Access Compliance Report
Public Rights-of-Way
(Curb Ramps)

Intersection ID: 18944 **Main Street:** GULFSTREAM_CT **Cross Street:** CLIFTON_MEADOW_DR **Location:** S

ADA ID: 5ED9CBD5FAB5 **Ramp Type:** PerpDiag **Initial Pass/Fail:** Pass **Overall Compliance:** No **Severity Score:** 10.25

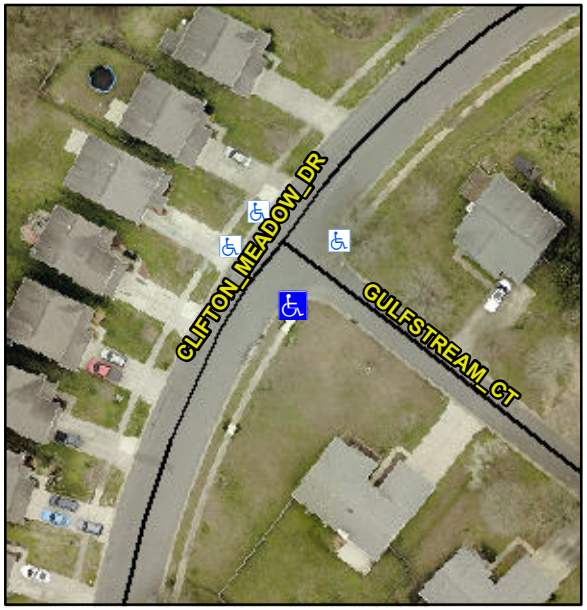
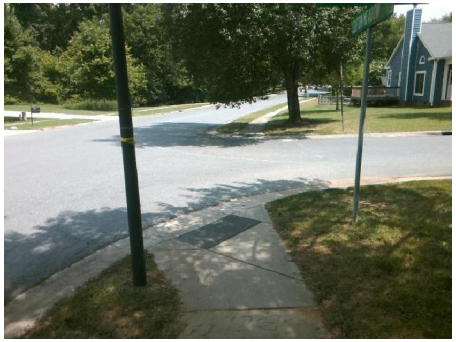
Not Found, R304.5.3, R304.2.1, R304.2.2-Perp, R304.3.2-Para

Compliance	Description	Data	Compliance	Description	Data
N/A	Ramp Length (in)	32.0	Yes	Ramp Slope (%)	5.5
Yes	Ramp Width (in)	48.0	No	Ramp XSlope (%)	3.3
N/A	Flare Type LT	Sloped	N/A	Flare Type RT	N/A
N/A	Flare Slope LT (%)	0.9	Yes	Flare Slope RT (%)	9.1
N/A	Flare Traversable LT?	Yes	N/A	Flare Traversable RT?	Yes
No	Landing Length (in)	N/A	Yes	DWS Provided?	Yes
No	Landing Width (in)	N/A	Yes	DWS Contrast?	Yes
No	Landing Slope (%)	N/A	Yes	DWS Length (in)	25.0
No	Landing X Slope (%)	N/A	Yes	DWS Full Width?	Yes
N/A	Landing Curb? (Y/N)	No	Yes	DWS Offset (in)	0.0
N/A	Shared Landing?	N/A			
Yes	Gutter Ponding?	No	Yes	Gutter Slope (%)	0.8
Yes	Gutter Lip Ht (in)	0.0	Yes	Gutter X Slope (%)	0.9
N/A	Painted X Walk1?	No	N/A	Painted X Walk2?	No
	X Walk 1 Direction	To NE		X Walk 2 Direction	To NW
N/A	X Walk 1 Width (in)	N/A	N/A	X Walk 2 Width (in)	N/A
	X Walk 1 Slope (%)	0.2		X Walk 2 Slope (%)	0.7

Remove & Replace Curb Ramp With Two New Directional Ramps or Equivalent.
